FREDERICK COUNTY PLANNING COMMISSION

TITLE: Adamstown Village, Section III, Lots 1-4

FILE NUMBER: S-678, AP 14638 (APFO N/A, FRO 14550)

REQUEST: **Agricultural Cluster Concept Plan Approval**
The Applicant is requesting Concept Plan approval for a 4-lot Agricultural Cluster subdivision on a 27.27-acre property.

Concept Plan Layout

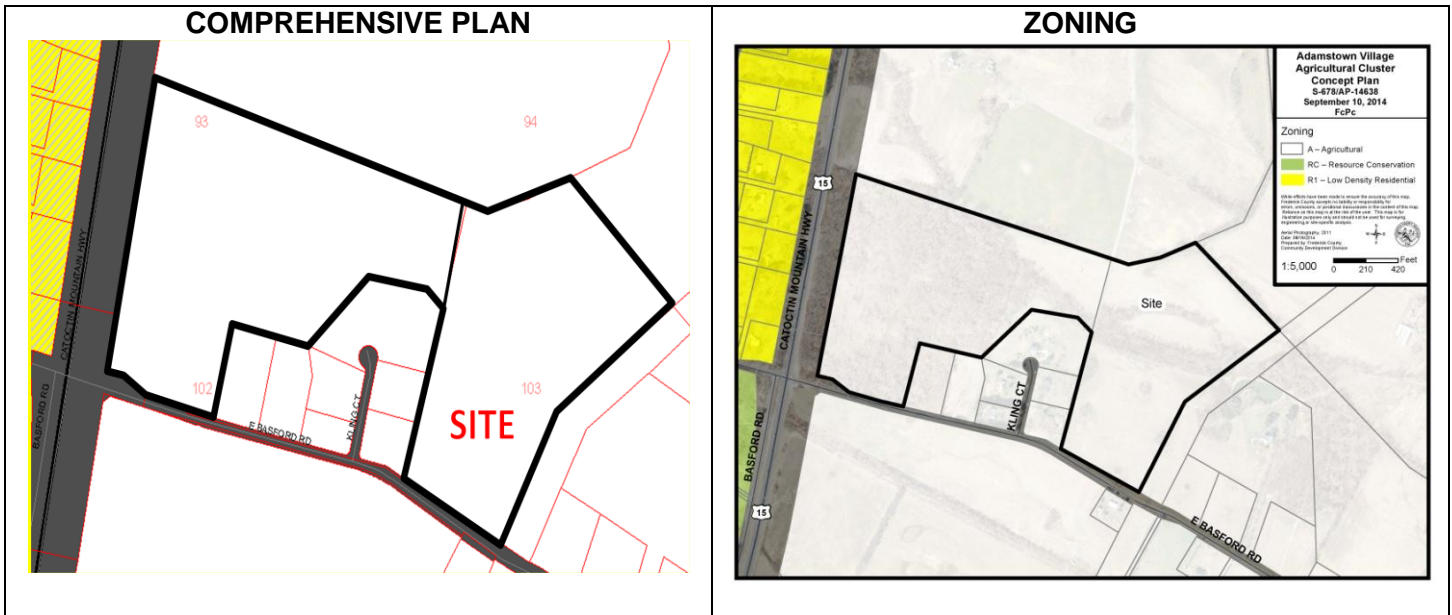
All of the proposed lots meet the minimum 40,000 sq ft lot size requirement. The proposed minimum lot width (100 feet) and yard areas (40 foot front yard, 30 foot rear yard, and 10 foot side yard) meet Agricultural District requirements in accordance with §1-19-6.100 Design Requirements of the Zoning Ordinance. The proposed average lot size is 1.69 acres, and the largest proposed lot is 1.99 acres.

The 1.69 average lot size is 0.19 acres above the required 1.50 acres as required in §1-19-7.300(C)(2)(c). However, §1-19-7.300 of the Zoning Ordinance gives the FcPc the authority to grant a modification to this requirement based on percolation testing and other Health Department requirements. As noted earlier in this report, percolation testing resulted in only five approved septic areas as shown on the Concept Plan. The wells for each lot must have a minimum 100 foot separation from all septic areas, and in the case of Lot 4 a 200 foot separation is required by the Health Department. Since the approved septic areas cannot be relocated and the wells must be located 100 or 200 feet away from all septic areas, the lots cannot be designed to meet the 1.50 acre average lot size requirement.

The proposed four-lot subdivision is situated in the southeast corner of the property, between the existing Adamstown Village subdivision and a Potomac Edison electric transmission line corridor. The entire property consists of Class I and II prime agricultural soils (these soils are shown and labeled on the Concept Plan). The site of the proposed subdivision consists of class II soils. However, there is no other area of the property with adequate road frontage for subdivision. The proposed subdivision location is adjacent to existing residential development.

The site design takes advantage of the site topography, wooded areas, water bodies, and adjoining subdivisions, and land uses. The area of the proposed subdivision avoids the wet, low-lying areas of the site. The stream valleys are not impacted. Very minimal forest clearing (0.10 acres) is proposed. As previously discussed, the proposed subdivision is located between the existing Adamstown Village subdivision and the Potomac Edison electric transmission line corridor.

The proposed lots will access a proposed 30' wide common access easement that will have a 12' foot wide paved travelway. East Basford Road has an existing 20 foot wide travelway. Lot access to East Basford Road will be via the common driveway that will be constructed over the panhandles serving lots 2, 4, and Lot 5- Remainder. Notes will be required on the final plat indicating that the lot owners shall be responsible for maintaining the common driveway. The common driveway must be constructed prior to lot recordation in accordance with §1-16-109(D)(8). Lot access will meet the Subdivision Regulation requirements.

Panhandles are proposed to serve Lots 2, 4, and 5-Remainder. Panhandles in minor subdivisions do not require a modification from the FcPc.

Staff finds that the FcPc may grant this modification as the lots cannot be designed to meet the 1.50 acre average lot size requirement due to the septic and well restrictions.

If the Planning Commission finds that the proposed subdivision meets the Ag Cluster provisions of the Zoning Ordinance, and grants a modification of the average lot size requirement in accordance with §1-19-7.300(C)(2)(c) of the Zoning Ordinance, then Staff has no objection to the conditional approval of the Concept Plan.
